OSS_055-052_PA_20180830_AUTHORIZATION
Texas Commission on Environmental Quality
Investigation Report

Regulated Entity Name: GMNP PINE SPRINGS
Regulated Entity Number: RN102878543

Investigation # 1513799
Investigator: MARIE GOMEZ
Conducted: 08/30/2018 -- 08/30/2018
Program(s): ON SITE SEWAGE FACILITY
Incident Numbers
Site Classification COMMERCIAL
No Industry Code Assigned
Investigation Type: Compliance Invest File Review
Location: CULBERSON
Additional ID(s): 055052

On August 30, 2018, Ms. Marie Gomez, Environmental Investigator with the Texas Commission on Environmental Quality (TCEQ) El Paso Region Office, reviewed a revised application for the proposed-On Site Sewage Facility (OSSF) at 400 Pine Canyon, Salt Flat (Culberson County), Texas. The application was assigned OSSF Permit #055052.

PINE SPRINGS - SITE PLAN

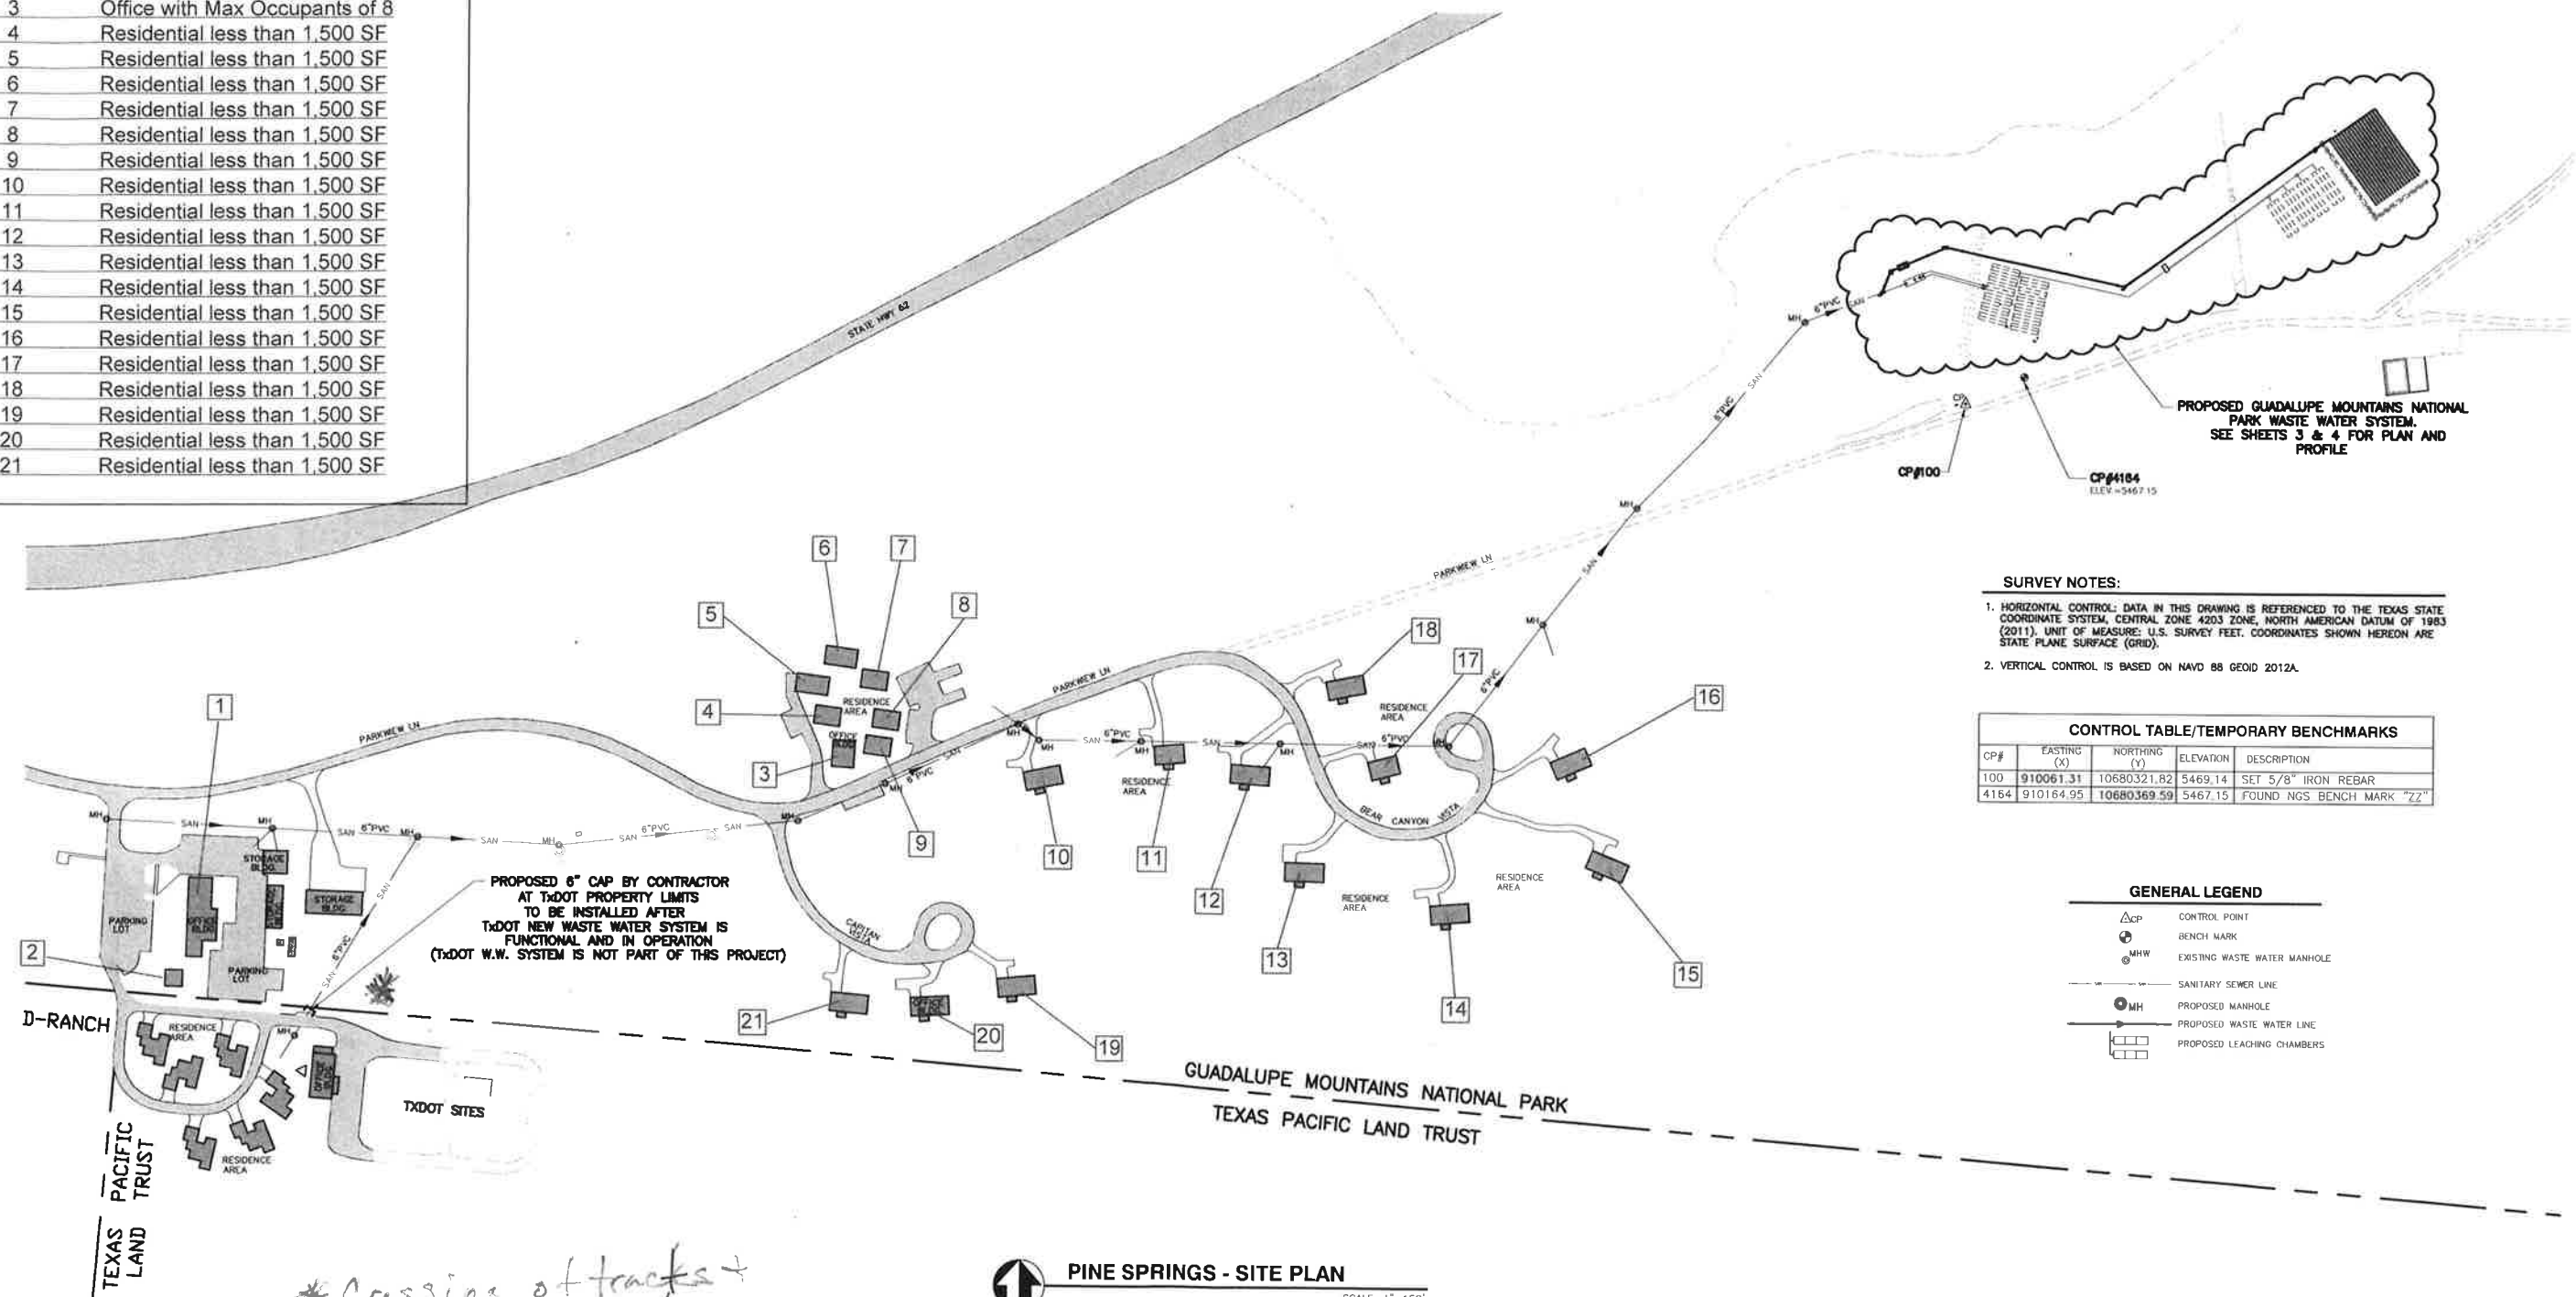
Item 1: Failure to design an OSSF system as per §285.8(4) the peak flow, calculated using either actual water use data or the data from §285.91(3) of this title, for each individual system is less than 5,000 gpd.

Item 2: Failure to design an OSSF system as per §285.8(5) the systems are used only for disposal of sewage produced on the tract of land where the systems are located.

1. TxDOT IS IN THE PROCESS OF DESIGNING AND OBTAINING A PERMIT FROM TCED FOR THEIR OWN SEPARATE SYSTEM INSIDE TxDOT PROPERTY. THE NATIONAL PARK WILL COORDINATE THE APPROPRIATE TIME OF DISCONNECTING TxDOT FROM THE EXISTING SYSTEM.

* Crossing of tracks +
over 5,000 gpd

Item 1: Mr. Salazar, contacted Tim Putnam, Project manager from Ridgeway Valley Enterprises Inc. about TxDOT needing their own separate waste water system in place first before cap is set. Mr. Salazar is waiting on a response from Mr. Putman to see what TxDOT's plan of action.
